Architectural Review Board Staff Report

Project Type: Amended Architectural Elevations

Description: **MPD Investments, Adjusted Lot 2 (Beyond Self-Storage at Chesterfield) - AAE:**
Amended Architectural Elevations and Architect's Statement of Design for a 2.99 acre tract of land zoned "PI" Planned Industrial District located north of North Outer 40 Road, west of its intersection with Boone's Crossing.

EXTERIOR ELEVATIONS

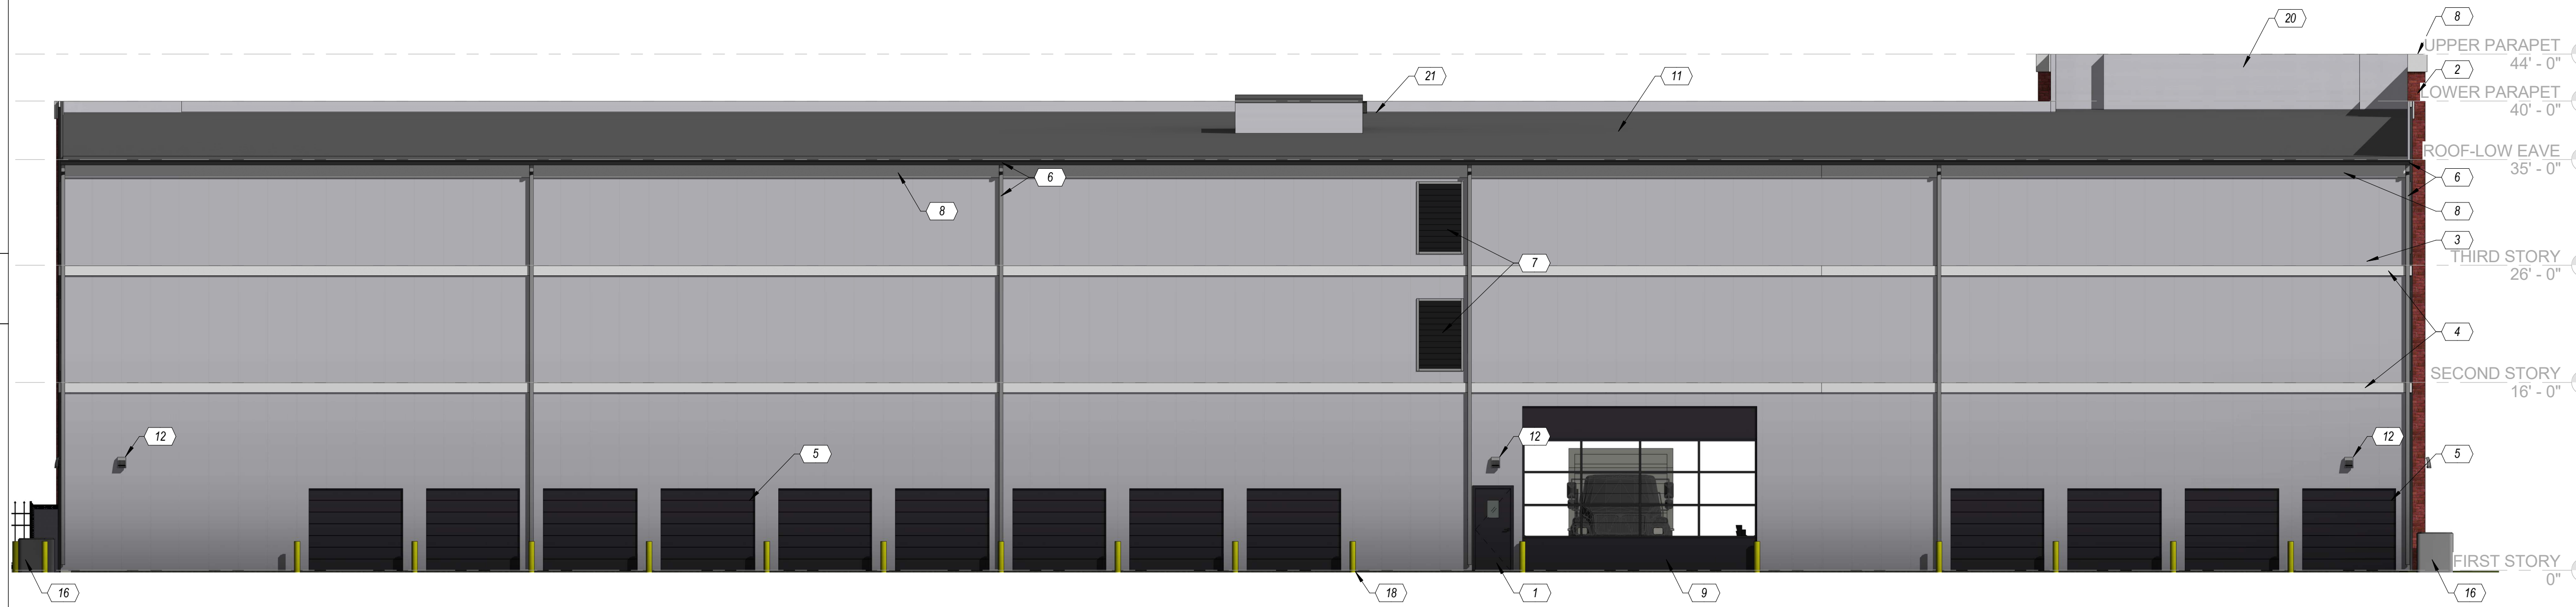
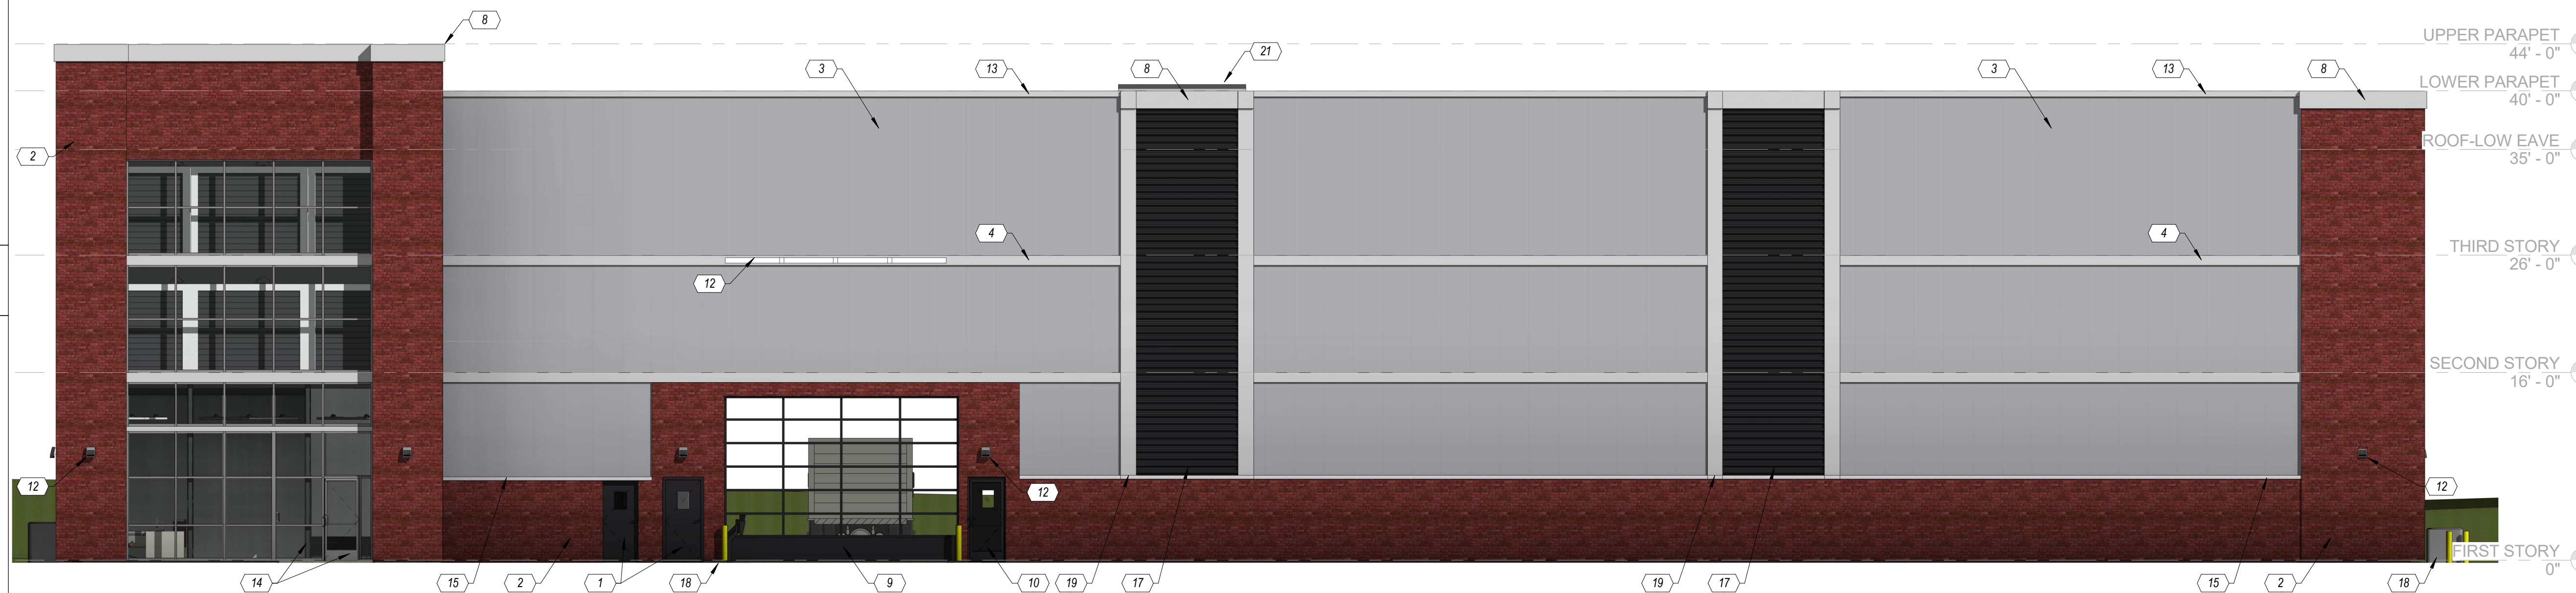
The proposed change replaces the previously approved brick with a Nichiha Brick panel. During the original approval for the project, it was recommended that the height of the brick be increased to the level shown on the submitted elevations from the originally submitted height of 3 feet. The applicant has included a rationale for the change to the material citing the structure of the wall system is unable to hold the additional weight of the thin brick. The proposed Nichiha brick panel system was chosen to replicate the aesthetic of the brick while reducing the weight. Staff has advised the applicant to bring a material sample to the meeting.

EXTERIOR ELEVATIONS

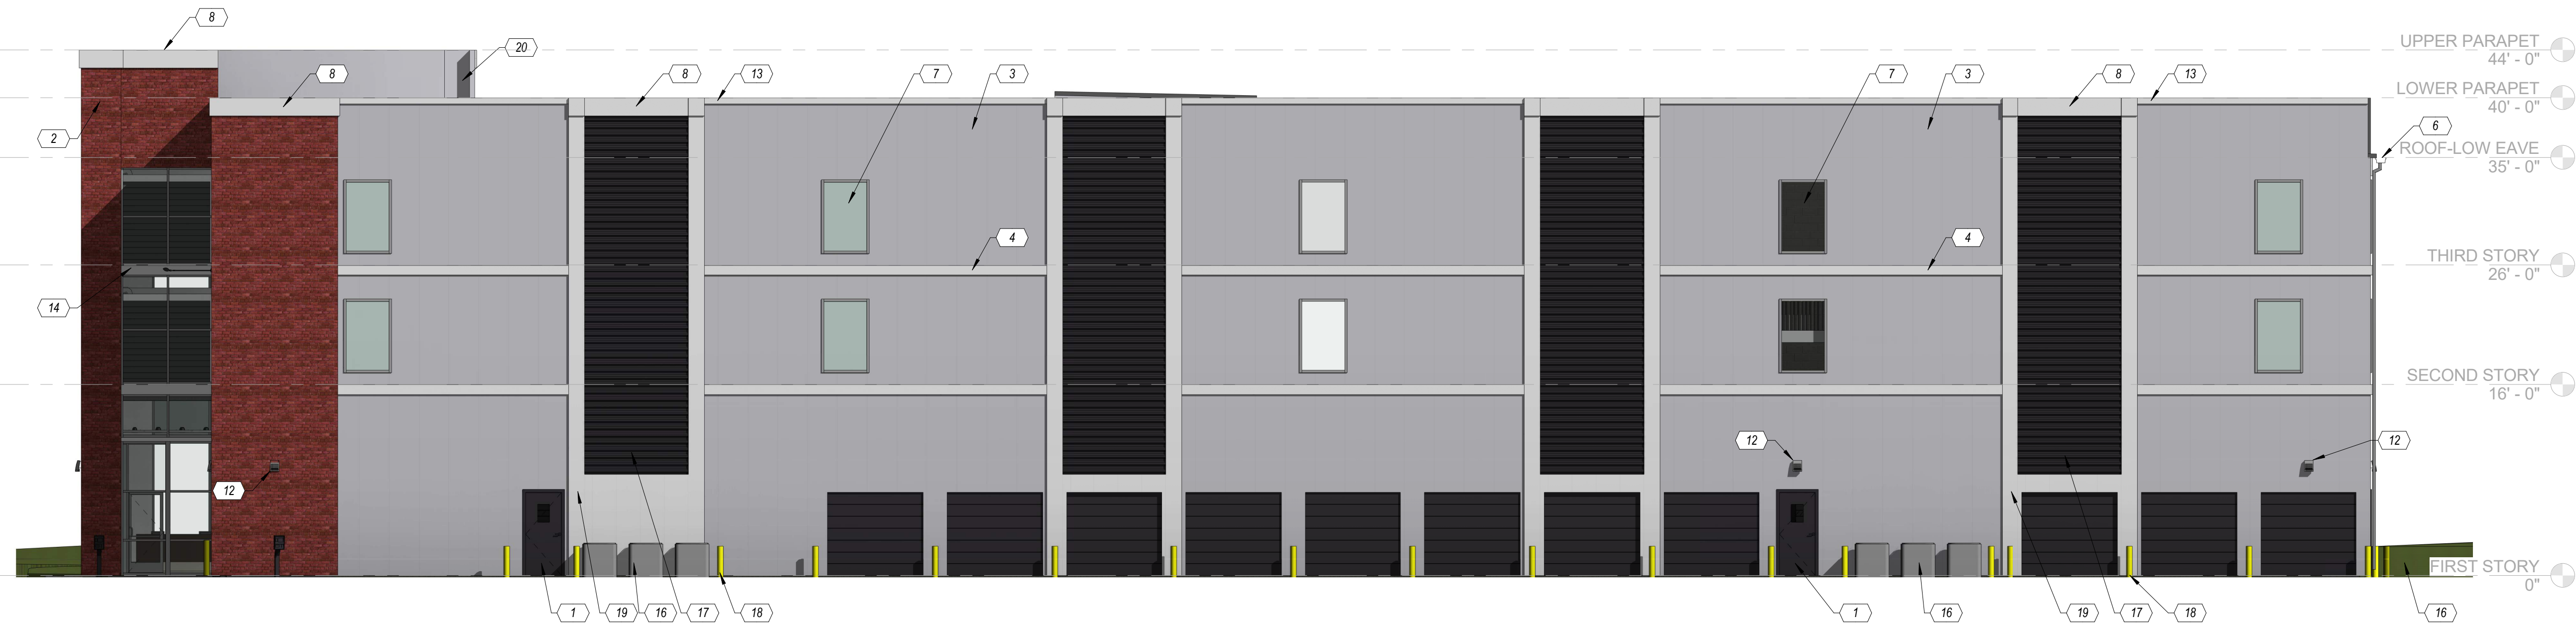
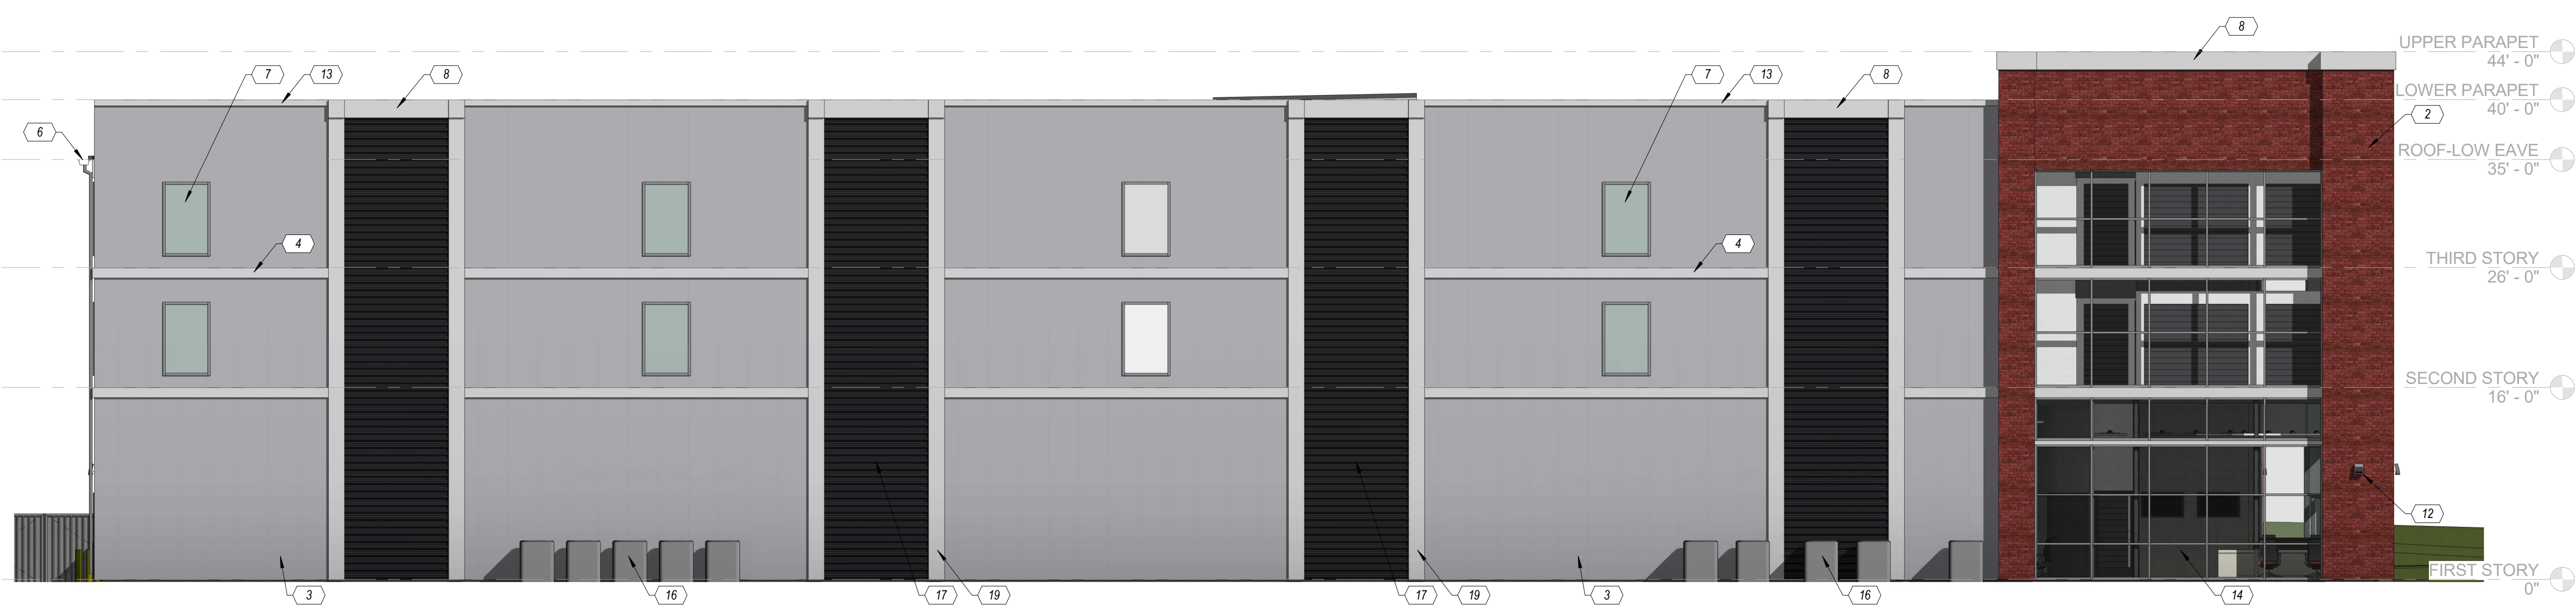
The original request showed all mechanical equipment located in one area along the western side of the building with screening provided by existing and proposed landscaping. The revision shows mechanical equipment being split into several areas along the building. To ensure compliance with the UDC, the applicant has indicated they will be installing additional landscaping adjacent to all mechanical equipment consistent with the original improvement.

- 4) *Landscaping design and screening*
- a) *(The following information is added to landscaping as describe in the Architect's Statement provided with the initial ARB submittal dated May 20, 2016.) Heating, Ventilating, and Air-Conditioning (HVAC) for the building is provided with 16 split-systems. These consist of interior furnaces/air-handlers and exterior compressors. These systems are similar to what typically may be found for residential projects, and*

the equipment for each split-system is similar in size as to what would be used for a residence. The furnaces/air-handlers are dispersed throughout the building for efficiency; they are located in the four quadrants of the building (NE, SE, SW, and NW). Also for efficiency purposes, the exterior compressor units are dispersed into four groups located near the four corners of the building. Six units are located on the east side of the building, three near the north corner and three near the south corner; these are located within the fenced portion of the project and will be visually screened from public view by the fencing. Ten units are located on the west side of the building, five near the south corner and five near the north corner; these will be screened with landscaping similar to what was included on the landscape plan provided with the initial ARB submittal, and per City requirements.
